## STAFF REPORT

TO: PLANNING COMMISSION

LOCATION: 6606 Alhambra Avenue @ Blue Ridge Drive (APN 164-340-005)

PROPOSAL: Study session to discuss and receive public input on application for Conditional Use Permit to allow attended car wash business, with replacement of existing service station building (containing small convenience market area and auto service areas), with new structure containing (approximate) 1,250 sq. ft. convenience market and car wash tunnel; and addition of new vacuum trellis and enclosures, on approximate 23, 000 sq. ft. site. Exceptions to normally required 15' minimum side and rear yards are also requested.

FIGURE 2: Measured Leq Values for Windshear Dryer With Silencer Package

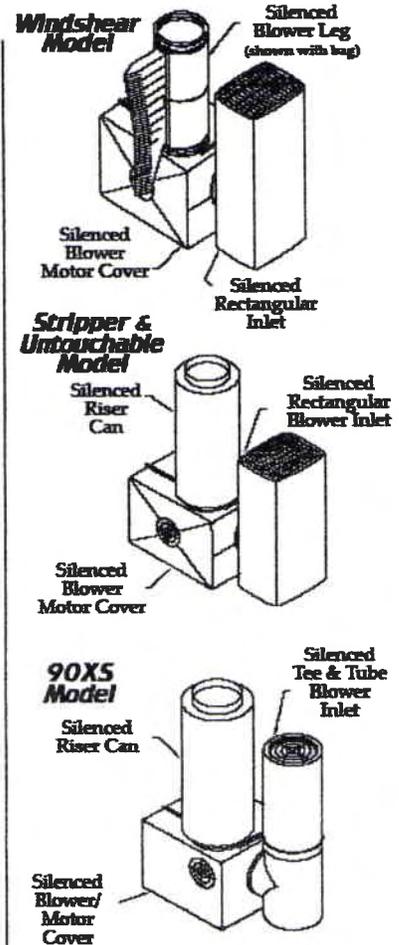
For the car wash and dryer with the Silencer Package the following duration data were gathered. The car wash duration is 4 minutes as the car moves forward slowly to exit on the conveyer and the dryer starts for a duration of one minute and 30 seconds. The total time is 5 minutes 30 seconds. Table 2 shows the duration breakdown for each phase, the percentage per hour and number of minutes per hour.

FIGURE 3: Site Plan Showing Unshielded Car Wash Noise Levels at the South And West Property Lines for the Martinez Site

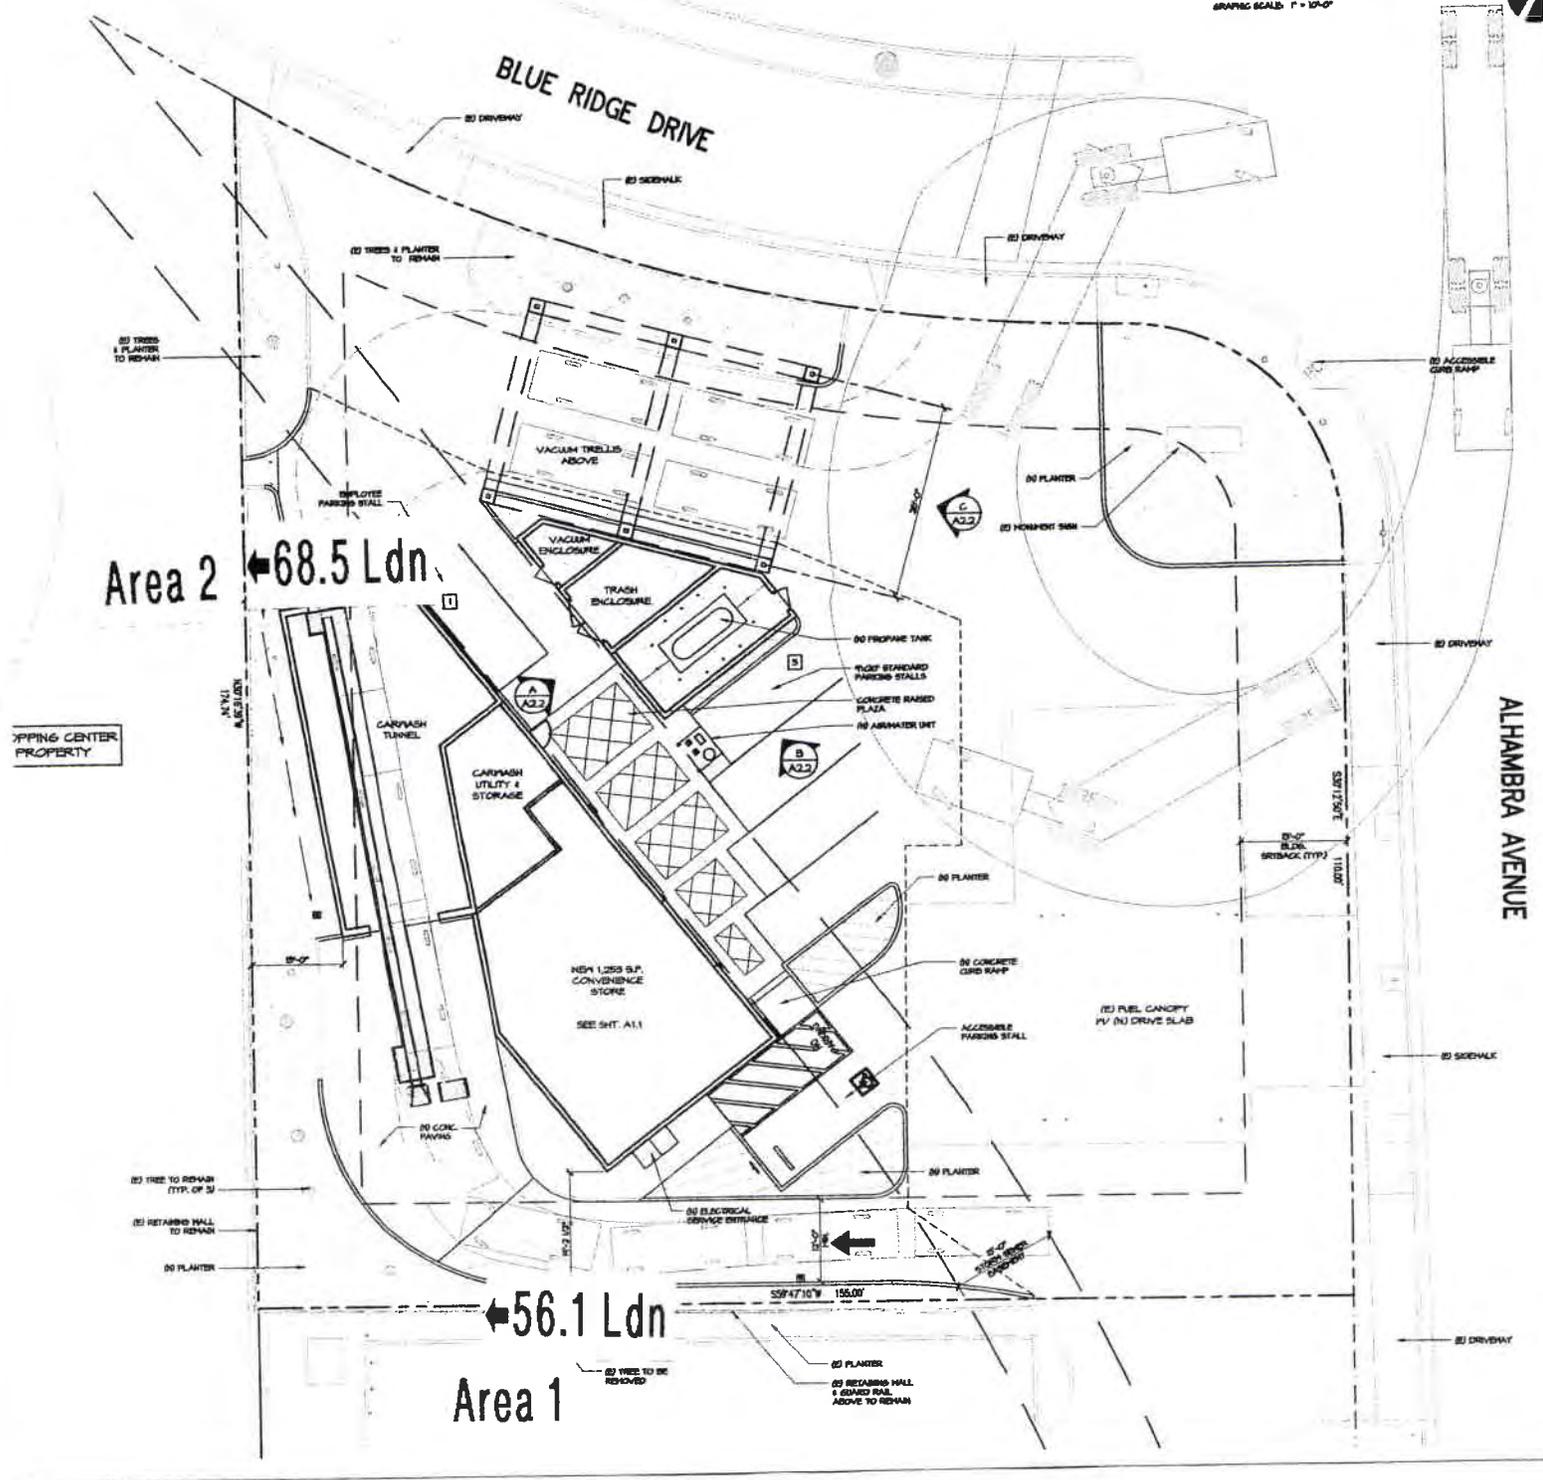
In Figure 3 there were two (2) areas selected to be evaluated. These were the closest areas to the car wash. The designated numbers for purposes of this study are shown in Figure 3 as Areas 1 and 2. At the south project side the worst-case noise impact at the property line, from the 180-degree angle of entrance side of the car wash is **56.1 dBA Leq**. At the west side (near the dryer) of the exit side the projected noise impact is **68.5 dBA**.

The Day-Night-average noise values (Ldn) in Table 3 at the west side (Area 2) are greater than 60 dB Ldn, which is above the City of Martinez noise limit.

Because the potential noise levels at the south and west project areas do exceed the allowable daytime criteria of 60 dBA Ldn, **acoustical shielding is required.**

-Place a 20 foot long sound wing wall from the exit side of the car wash on the north side.

At the northwest side place an 8-foot high, 20-foot long wing wall along the property line. This wall will shield the car wash impacts to less than 60 dB Ldn. See Table 4. This table shows the mitigated noise levels of 51.9 dB Ldn with an eight (8) foot high wall in use.

FIGURE 6: Site Plan Showing Distance to Vacuums From West Property Line

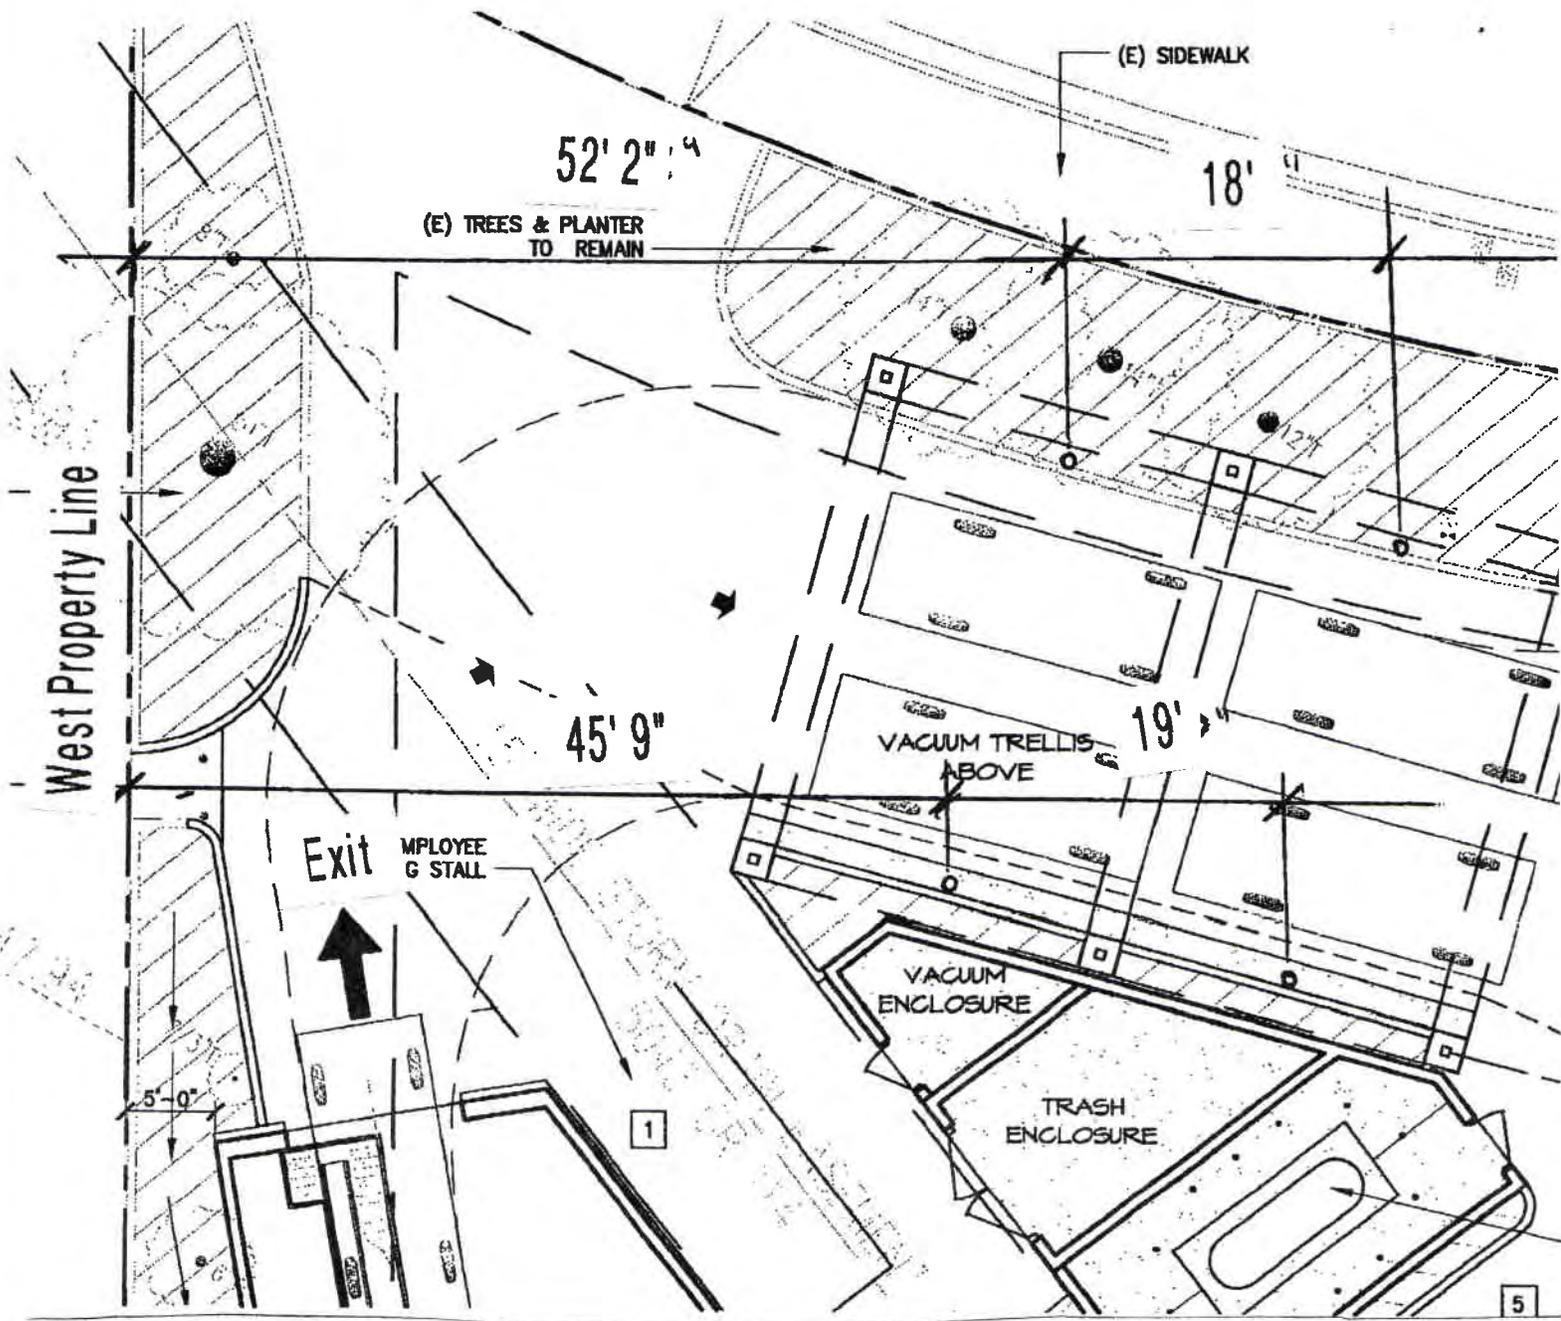
There are vacuums trellis planned near the exit side of the car wash location at the west side. The vacuums are located about 46 feet from the western property line. The reference vacuum noise impact is 75 dBA at a distance of 2 feet. Projected to 46 feet the noise impact drops off to 47.8 dBA. The shielded impacts are less than 60 dBA.

RESIDENTIAL PROPERTIES  
IN QUESTION -  
(6601, 107, 103, 102)

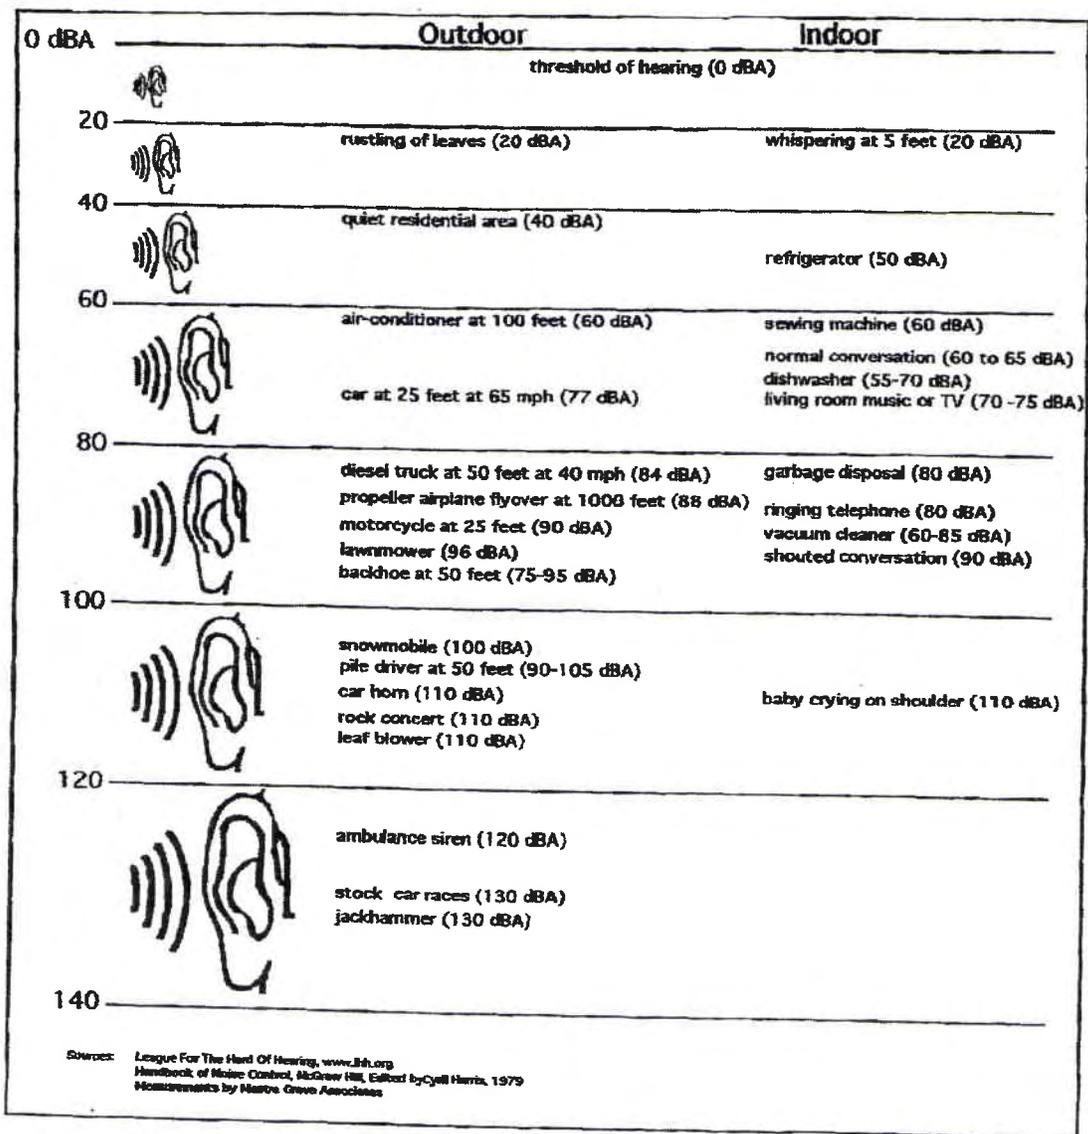
At the request of the City planner I am providing additional information for the above referenced project. The car wash noise levels were projected to four (4) additional addresses: 102, 103, 107 Henson Creek Court and 6601 Blue Ridge Drive.

Address	Distance	Projected Noise Level
103	186'	49.2 dB Ldn
102 & 107	195'	48.7 dB Ldn
6601	265'	46.1 dB Ldn

All of these projected noise level values are less than the City nighttime noise standard of 50 dB Ldn and thus, meet the City noise limits. No further measures are required.
